**INTEGRAZIONI ISTRUTTORIA VIA
CDED 05: ANALISI ULTERIORI ALTERNATIVE
PROGETTUALI - VOLTRI**

**NODO STRADALE E AUTOSTRADALE DI GENOVA
ADEGUAMENTO DEL SISTEMA A7 – A10 – A12**

PROGETTO DEFINITIVO

Figura 8 – Stralcio planimetrico con Soluzione A

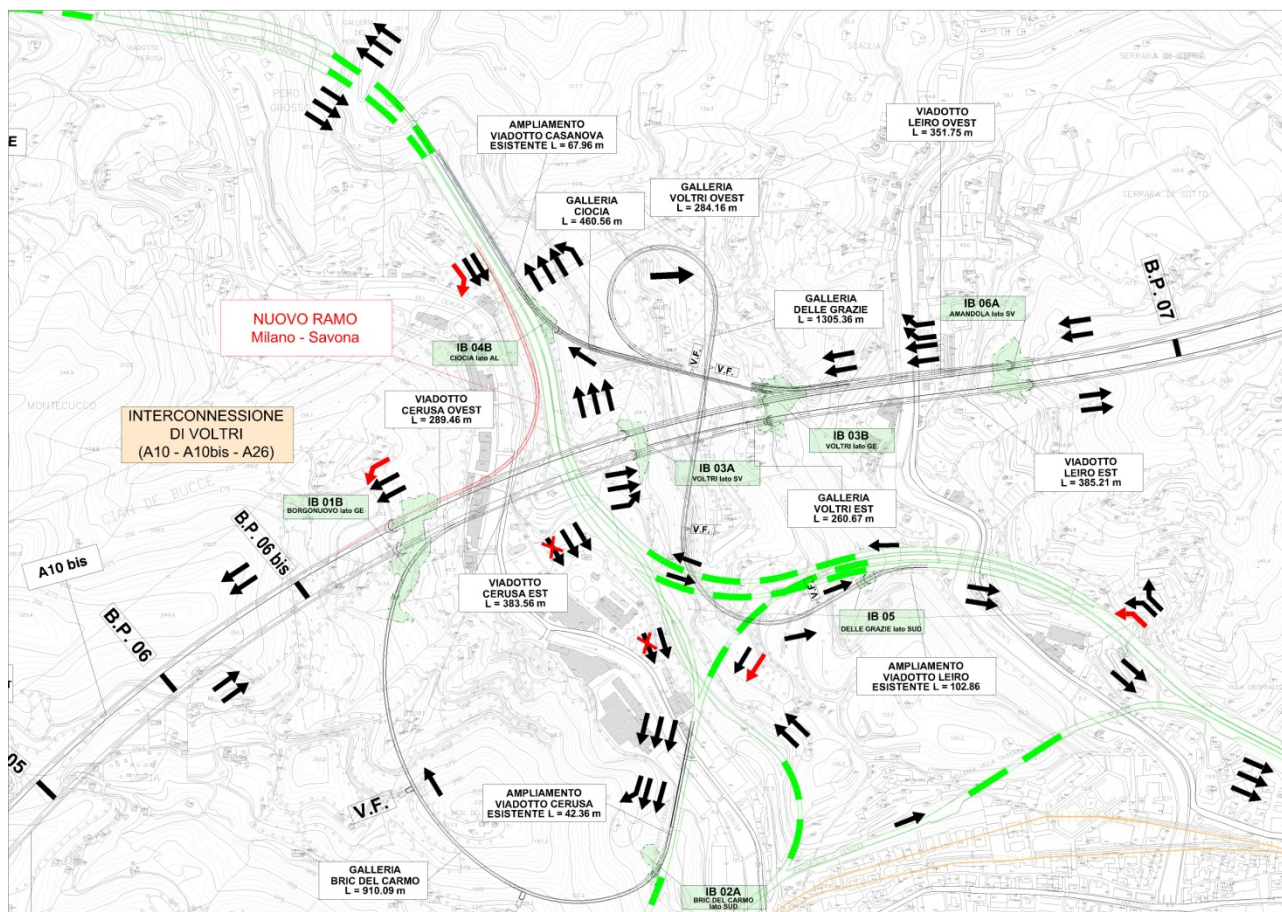
“l’intersezione fra la direttrice Milano – Savona e la direttrice GE Voltri – Gronda è prevista sull’esistente viadotto Cerusa nord, per imboccare la nuova galleria Bric del Carmo, già oggi interessato dalla una velocissima confluenza del flusso Milano – Savona sulla direttrice Genova – Savona. La tratta di viadotto che il progetto prevede di dedicare a questo pericoloso intreccio è molto breve, dato che si limita ad un rettilineo di soli 250 metri circa, per cui questa soluzione deve essere rivalutata con grande attenzione (necessità di integrazione progettuale specifica!), tanto più che una rilevante componente della direttrice GE Voltri – Gronda sarebbe inevitabilmente costituita dai veicoli pesanti obbligatoriamente dirottati dalla tratta GE Voltri – GE Aeroporto della A10. Per eliminare questo intreccio si propone di introdurre un ramo supplementare per la direttrice Milano – Savona o in alternativa per quella fra Voltri e la Gronda, similmente a quanto richiesto da ANAS per eliminare una intersezione simile prevista nella galleria Baccan della nuova carreggiata nord della A7, dove il flusso Livorno – Gronda si intreccia con quello fra GE Ovest e Milano.”

La richiesta di modifica progettuale prevede la realizzazione di un nuovo ramo con diversione in destra a nord del viadotto Cerusa. Al fine di superare il dislivello tra la A26 esistente e la A10bis in corrispondenza del nuovo viadotto, il tracciato prevede l'allargamento del viadotto esistente e la realizzazione di un nuovo viadotto (lunghezza circa 610 m) che scavalca la vallata del torrente Cerusa; l'introduzione di questo collegamento comporta inoltre la realizzazione di un allargamento della sezione della galleria (per un tratto di 155 m) nel tratto iniziale della galleria Borgonuovo realizzata con scavo meccanizzato in contesto amiantifero. La soluzione ridurrebbe l'entità dei flussi nel tronco di scambio ma non eliminerebbe il tronco di scambio.

Le soluzioni proposte erano già state previste nel progetto preliminare del 2008, successivamente modificato nell'ambito del Dibattito Pubblico. L'attuale configurazione risulta verificata dal punto di vista funzionale e riduce l'impatto sul territorio, andando peraltro incontro a quanto richiesto dalla Soprintendenza, con riferimento all'interferenza con il Parco della Villa Duchessa di Galliera. La soluzione attuale limita gli attraversamenti in viadotto ai soli tratti autostradali.

L'accoglimento della richiesta potrebbe prevedere due diversi layout modificati (si vedano le soluzioni A e B di seguito riportate), previa valutazione per entrambi della funzionalità del sistema. L'inserimento di un'ulteriore rampa di interconnessione dà origine, in entrambi i casi, a sdoppiamenti di percorso che rendono difficoltosa la gestione dei flussi veicolari.

Alla luce delle precedenti considerazioni circa la riduzione degli impatti dell'interconnessione e dell'adeguatezza del tronco di scambio previsto in progetto non si ritiene pertanto di accogliere la richiesta di apportare modifiche al layout del Progetto Definitivo di giugno 2011.

Figura 9 – Stralcio planimetrico con Soluzione B

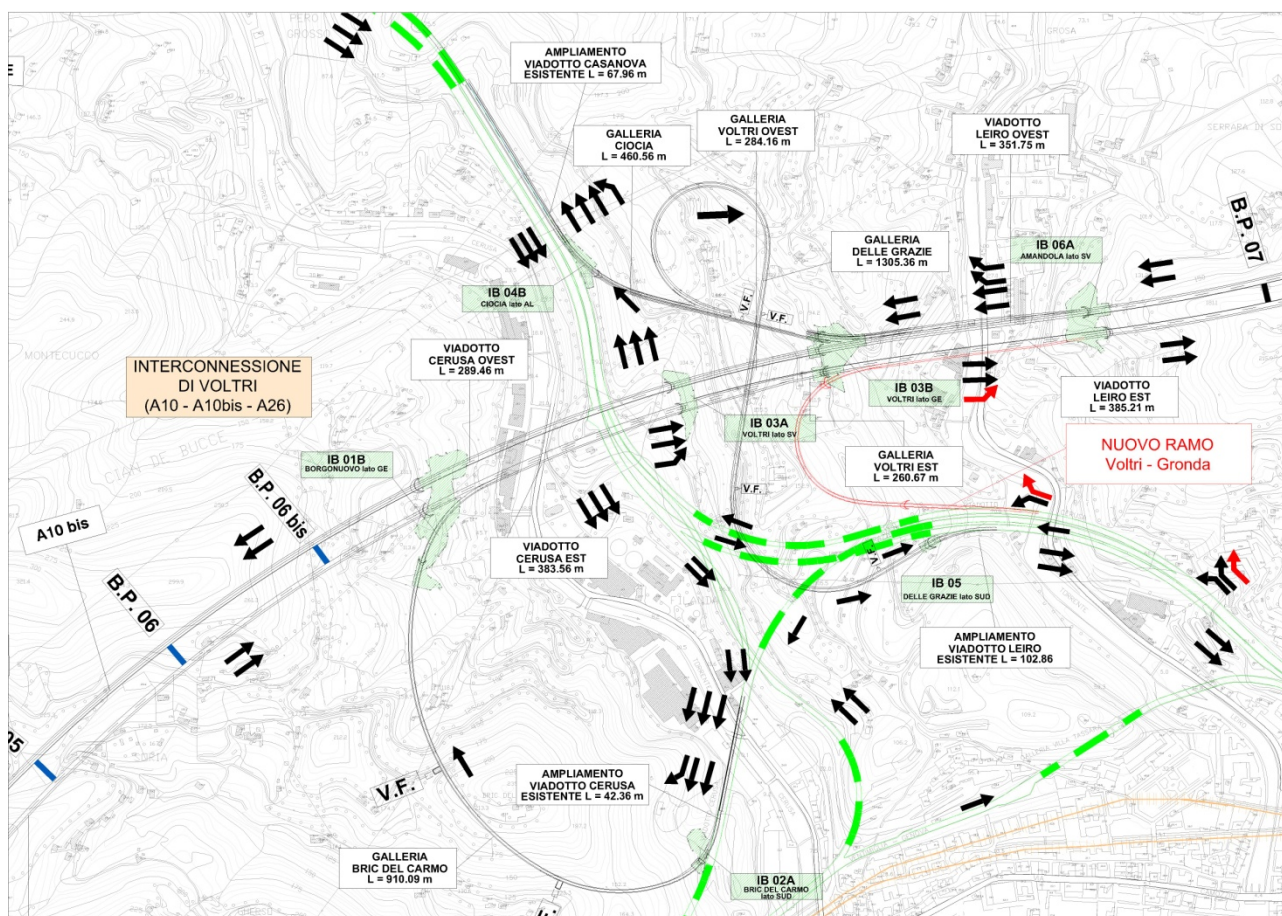
La richiesta di modifica progettuale prevede la realizzazione di un nuovo ramo di collegamento con diversione in destra in corrispondenza del viadotto esistente Leiro e la realizzazione di una nuova galleria, di sviluppo pari a circa 380 m, con imbocchi nel parco della Villa Brignole-Sale, in prossimità degli imbocchi delle gallerie esistenti e della galleria Delle Grazie.

Figura 10 - Corografia Situazione Attuale con modifiche apportate da PD (2011)

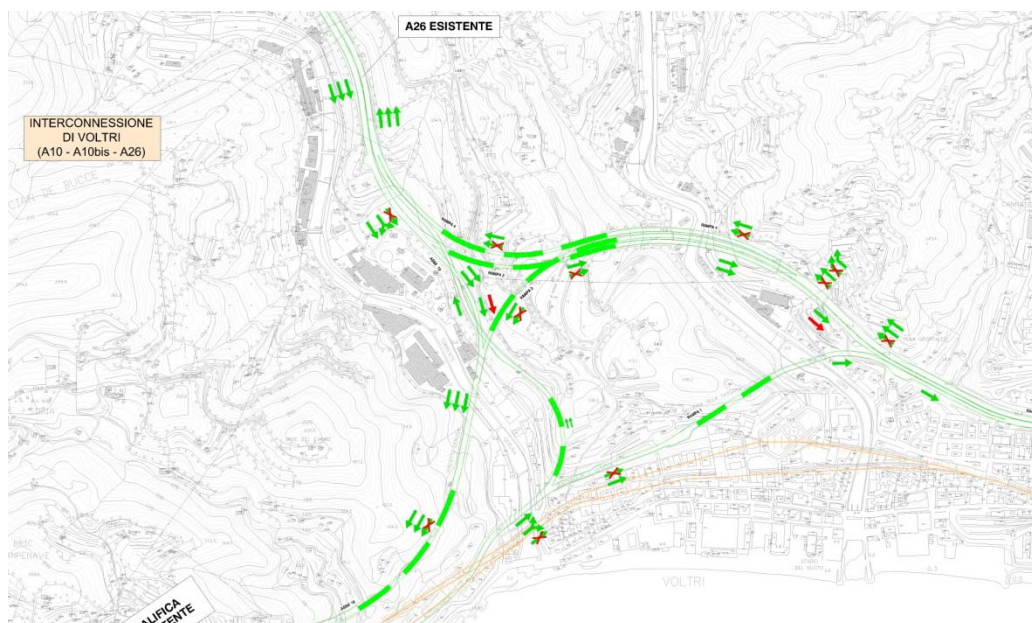
“l’asse Savona – GE Voltri transita, nello stato di fatto, all’aperto pochi metri a valle dell’ospedale di Voltri. Si ritiene quindi indispensabile che questa specifica situazione venga approfonditamente analizzata in occasione dello sviluppo esecutivo del progetto, prevedendo di conseguenza i necessari interventi di mitigazione ed in caso gli stessi non risultassero pienamente risolutivi anche eventualmente la realizzazione di un asse sostitutivo in galleria.”

Nel progetto definitivo il collegamento Savona-Genova Voltri è modificato riducendo la sezione ad una sola corsia (per effetto dell'eliminazione del traffico passante); rimanendo solo la componente di traffico locale l'impatto acustico risulterà sicuramente ridotto rispetto all'attuale. Si precisa inoltre che la protezione acustica dell'edificio ospedaliero rientra tra gli interventi del Piano di Risanamento Acustico (macrointervento n° 6 - intervento 2e); è prevista la realizzazione di una barriera di 176 m di lunghezza e 6 m di altezza con uno sbalzo di 5,5 m. Detta soluzione è stata concordata con la Direzione Sanitaria e con il Comune di Genova ed è stata approvata con apposita Conferenza di Servizi. Inoltre, come precedentemente anticipato, il Progetto Definitivo di giugno 2011 con la riduzione del tratto ad una sola corsia, apporta un miglioramento alla attuale situazione dal punto di vista acustico; pertanto l'intervento di risanamento previsto risulta adeguato.

Figura 12 - Corografia Progetto Definitivo

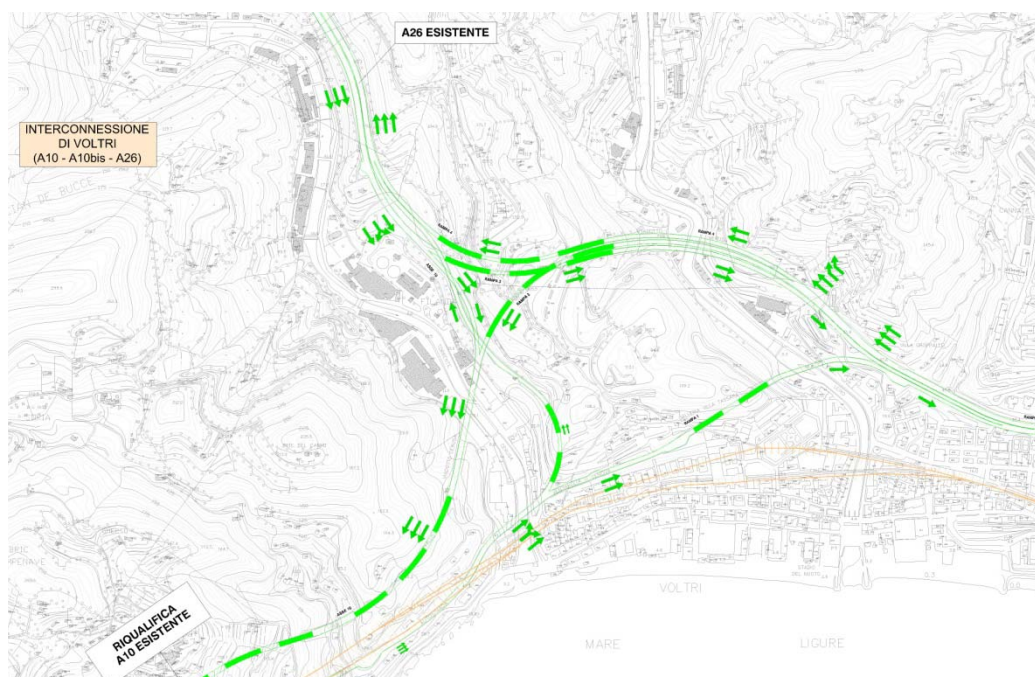
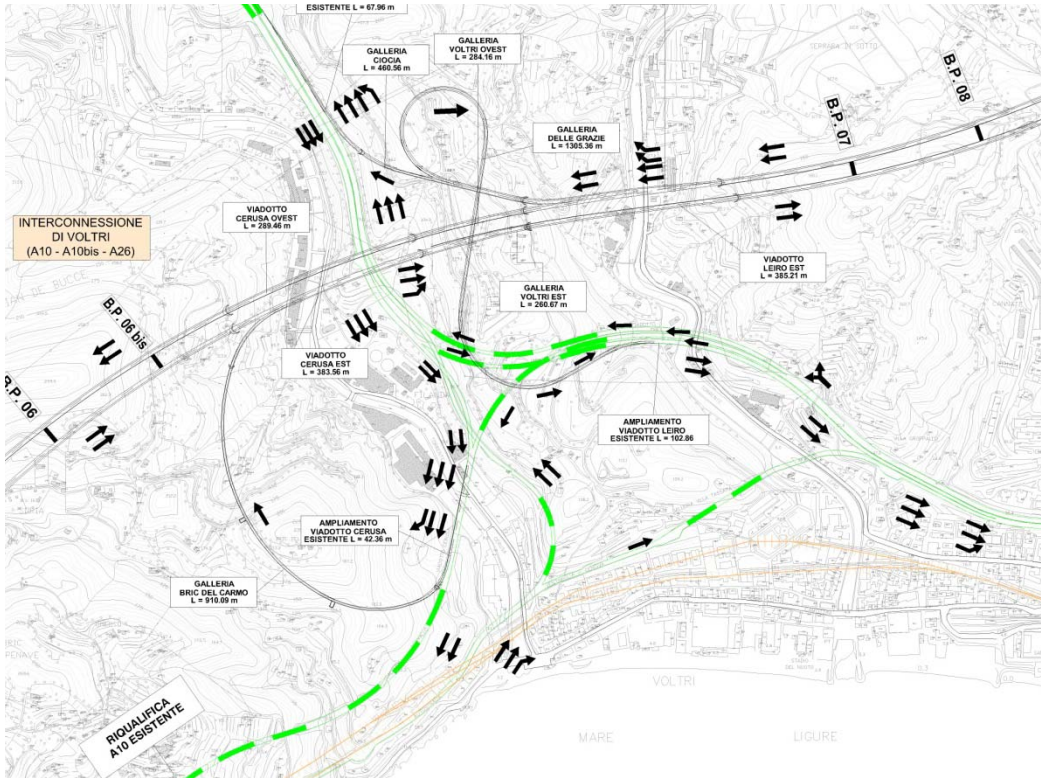
“il progetto non prevede di modificare l’esistente confluenza in salita fra la direttrice Savona – A26 e la direttrice Genova – A26, nonostante si tratti notoriamente di un punto criticissimo della rete che puntualmente ogni domenica determina ingenti accodamenti dei veicoli in rientro dalla Riviera; la causa sta nel fatto che la direttrice Savona – Milano può disporre solo di una corsia, perdipiù in salita, mentre alla direttrice Genova – Milano, sostanzialmente scarica nei giorni festivi, sono dedicate due corsie. Sarebbe opportuno che la realizzazione della Gronda costituisse l’occasione per eliminare questa disfunzione ed ancor più sarebbe necessario che questo intervento puntuale risultasse propedeutico, dato che subito a monte di questo punto critico è prevista l’installazione di un cantiere destinato a restringere la carreggiata per un periodo molto lungo”.

Nel progetto definitivo è già prevista la rifunzionalizzazione della confluenza, mediante la geometrizzazione del flusso Savona-Alessandria/Milano a due corsie (anziché a una come

oggi) e l'immissione del flusso Genova-Alessandria/Milano in destra a 1 corsia. La richiesta della Regione Liguria può quindi ritenersi accolta nel layout del Progetto Definitivo di giugno 2011.

La rifunzionalizzazione della confluenza risulta attuabile solo a valle del completamento delle opere relative alla Gronda di Ponente e delle rampe di interconnessione.
